La Jolla Shores Planned District Advisory Board (LJSPDAB) APPLICANT PROJECT INFORMATION FORM

- Project Tracking System (PTS) Number/Accela "PRJ" Number and Project Name (only submitted projects to the Development Services Department can be heard as action items):
PRJ-1114539

WILLIAMS COTTAGE

Building Construction Plans PRJ-1112693.pdf

SHEET TITLE:
SITE PLAN
 DATE:
4.30.2024

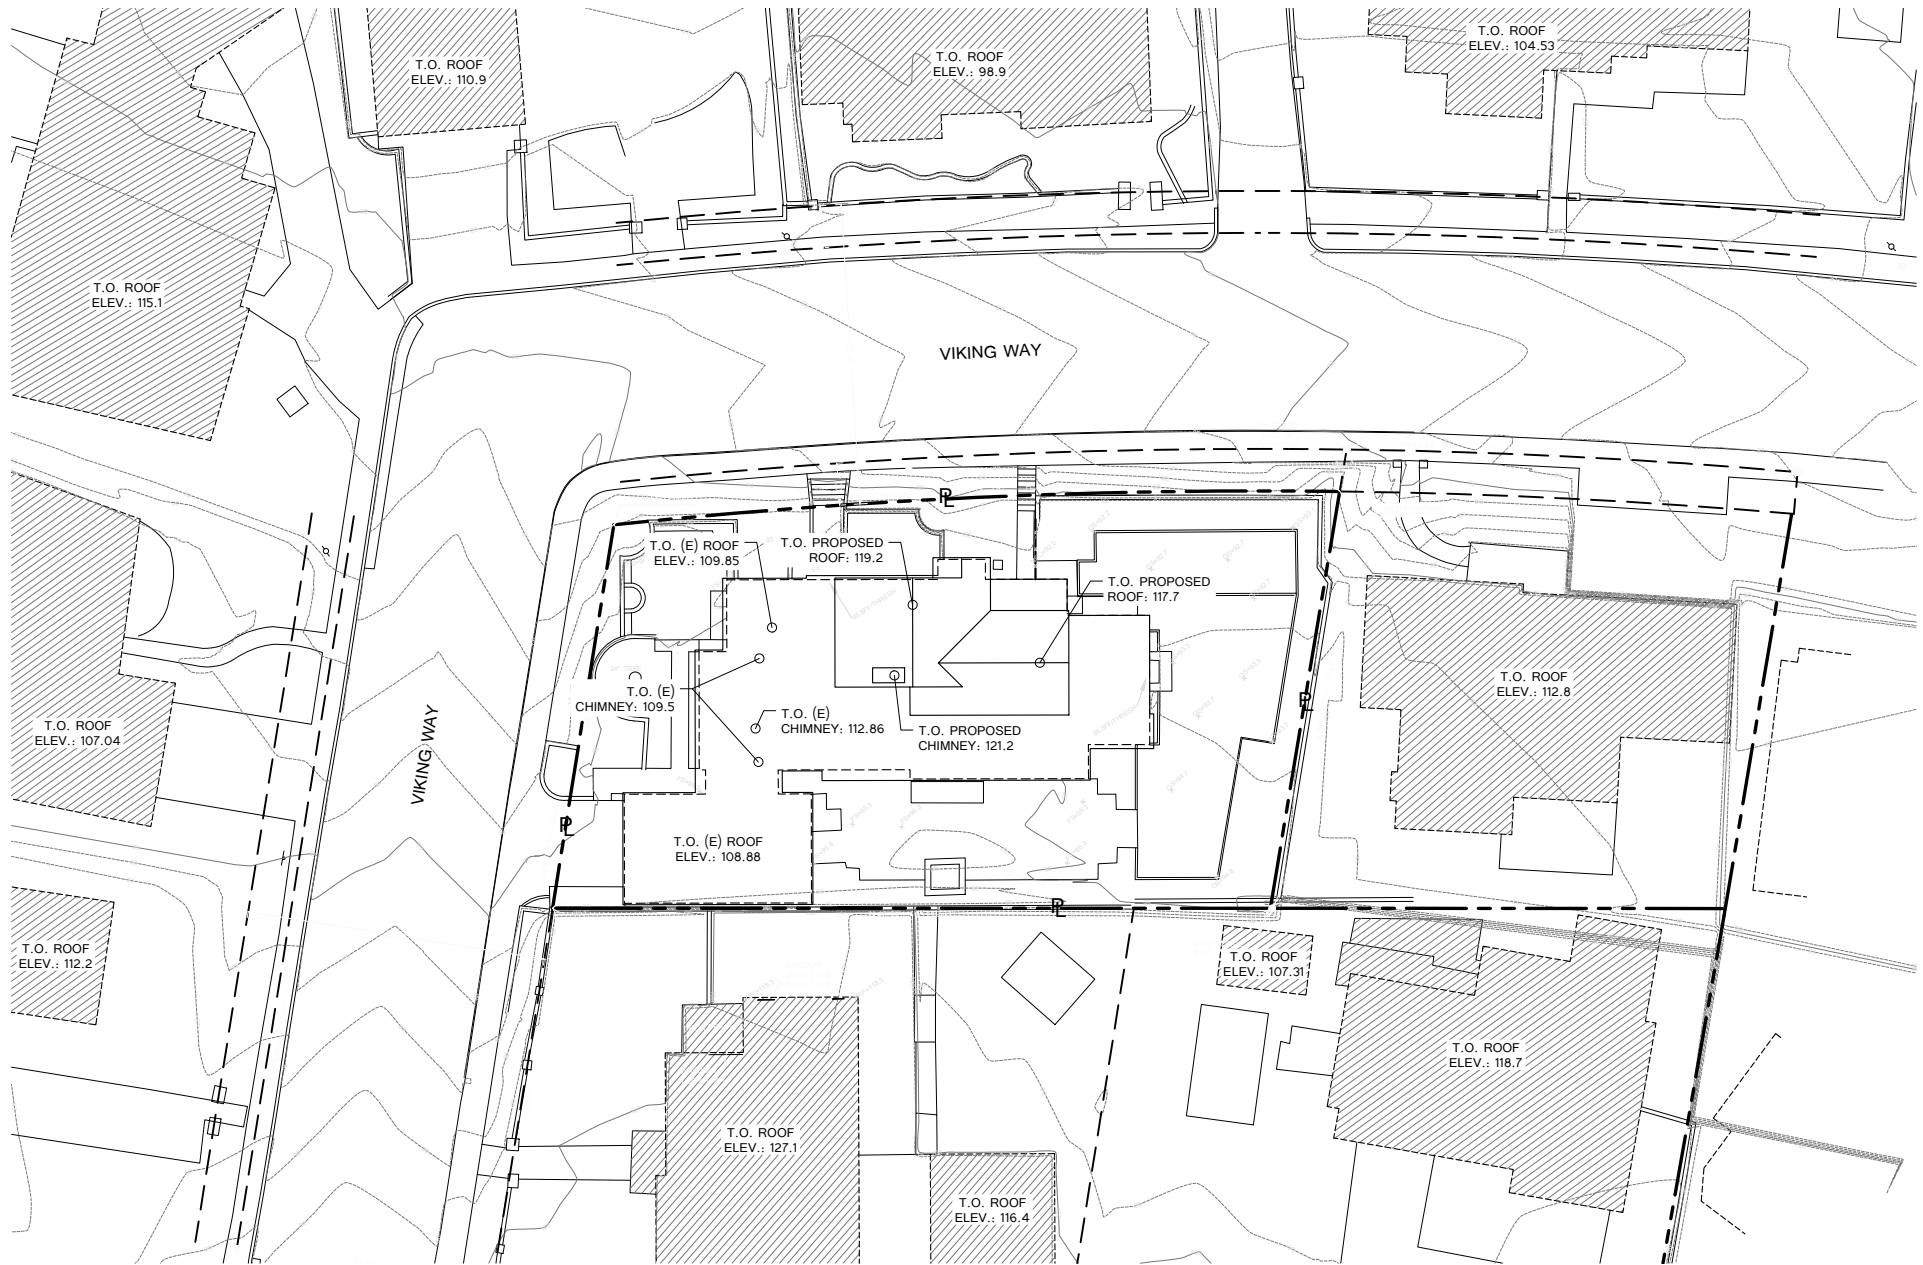
Show contour lines or spot elevations to support direction of drainage arrows on site plan . Include downspout locations and indicate how storm water will be routed to pervious surfaces.

TS-1: Revise Scope Of Work on TS-1 to include new 54" high stucco walls for new Trash Enclosure shown on Site Plan on TS-1.

TS-1: Revise Site Plan on TS-1 to show and dimension the Fire Separation Distances for the existing SDU building with proposed Additions.
